Wellington City Proposed District Plan

Section 42A Report under the Resource Management Act 1991 for:

Hearing Stream 9 – Transport

REPORT FOR:	Independent Hearings Commissioners
SUBJECT:	Wellington City Proposed District Plan – Hearing Stream 9 – Transport
PREPARED BY:	Andrew Wharton
REPORT DATED:	10 May 2024
DATE OF HEARING:	10 June 2024

Figure 1 – TR: Cycle and micromobility parking

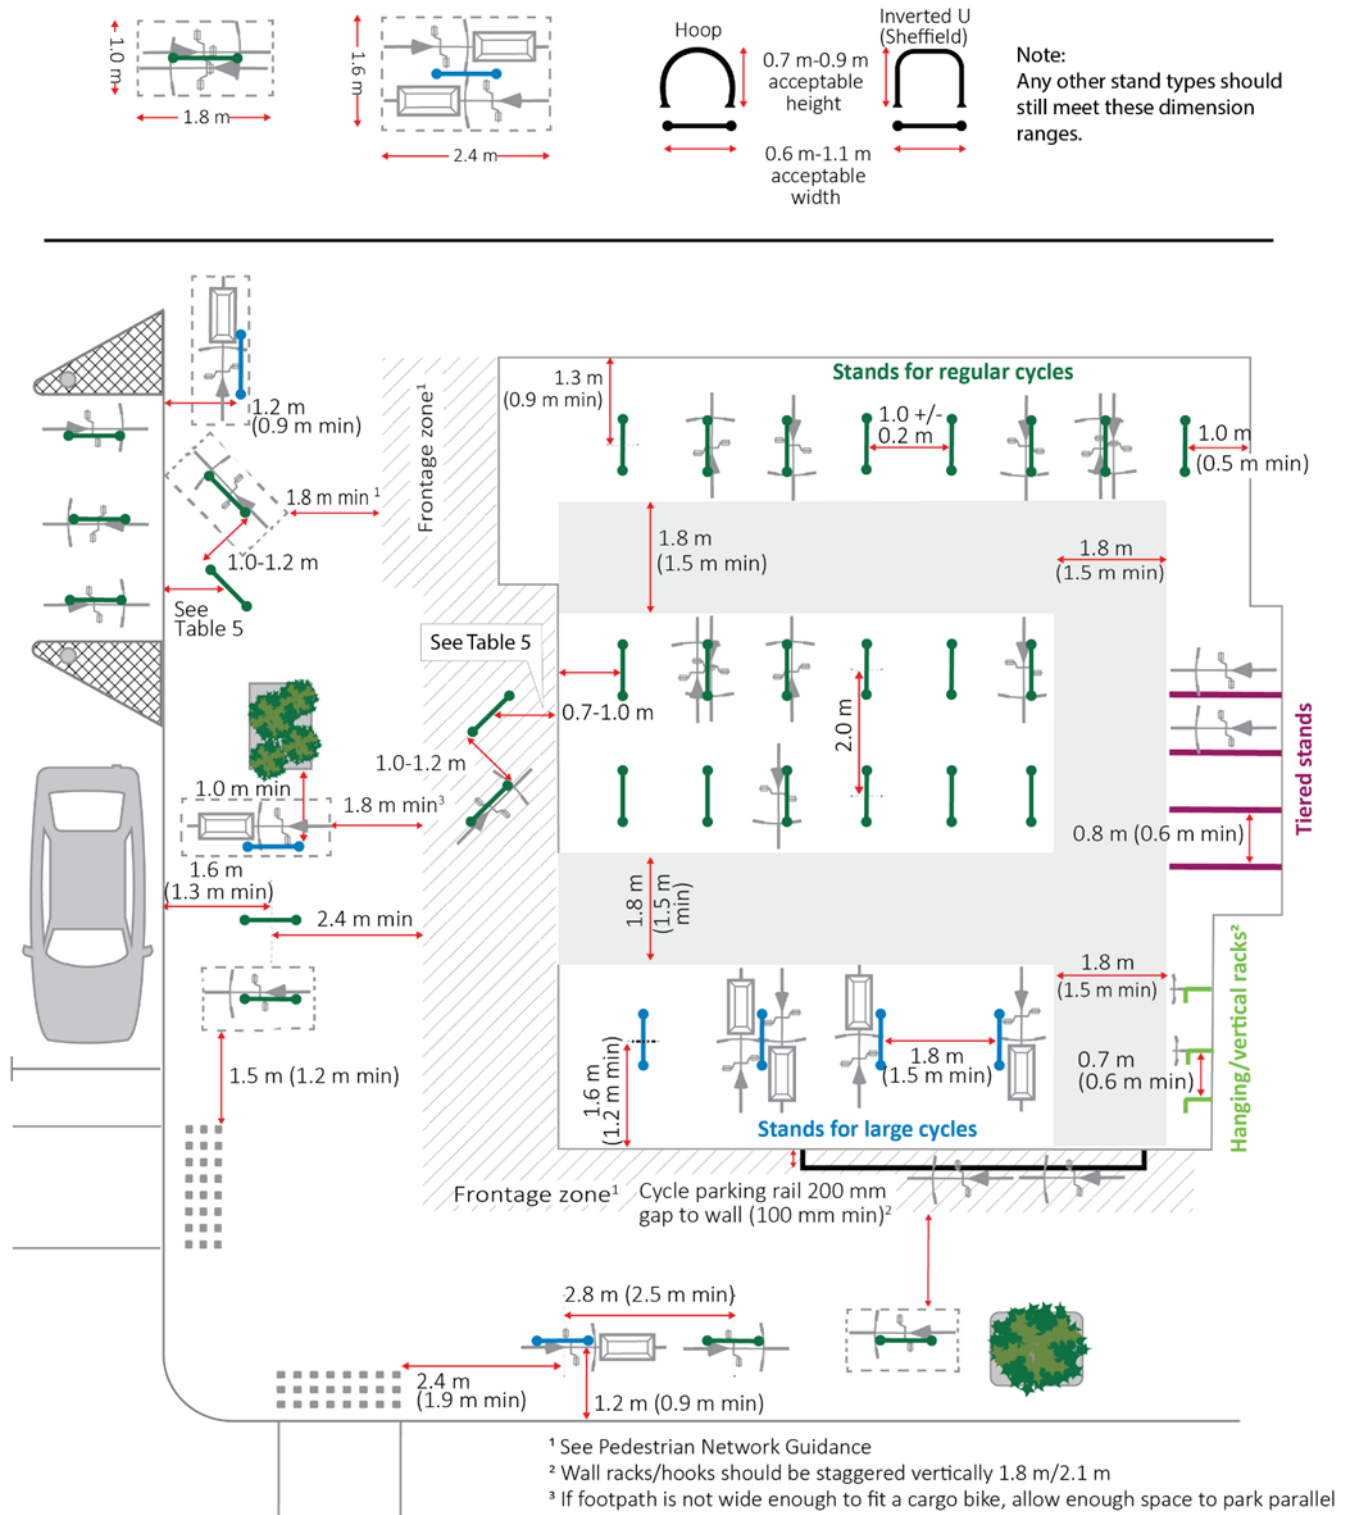
240. I agree with Mr Lieswyn's evidence that the TR-S3 standards are too small and limited. In accordance with his evidence, I recommend adding Figure 16 and Table 5 from the 2022 Waka Kotahi Technical note¹⁹ he references, and related standards in his evidence, with only minor changes for PDP workability (e.g. "may" to "must"). Where these standards conflict with standards in TR-S3 I recommend these be deleted. This addresses the submitters' concerns that the current standards are too small and do not account for e-bikes, cargo bikes and micromobility options.

- ~~a. Stands must be sized and spaced to accommodate cycle dimensions of 1200mm high, 1800mm long and 600mm wide;~~
 - a. Note that all dimensions in Figure 1 – TR and Table 7B – TR are based on cycle envelopes and a 1.0 m long cycle stand. Adjust if using different stands or if providing for different types of cycles.

2. Hanging racks or vertical stands that require lifting of the bicycle must not exceed 50% of number of spaces.
 3. At least one in every four cycle/micromobility parks on a site must meet the standards for “large cycles” in Figure 1 – TR.

282. **HS9-TR-Rec18:** That new Figure 1 – TR: Cycle and micromobility parking, Table 7B – TR: Minimum distance from centre of stand to a wall or kerb and associated Note be added as shown below.
-
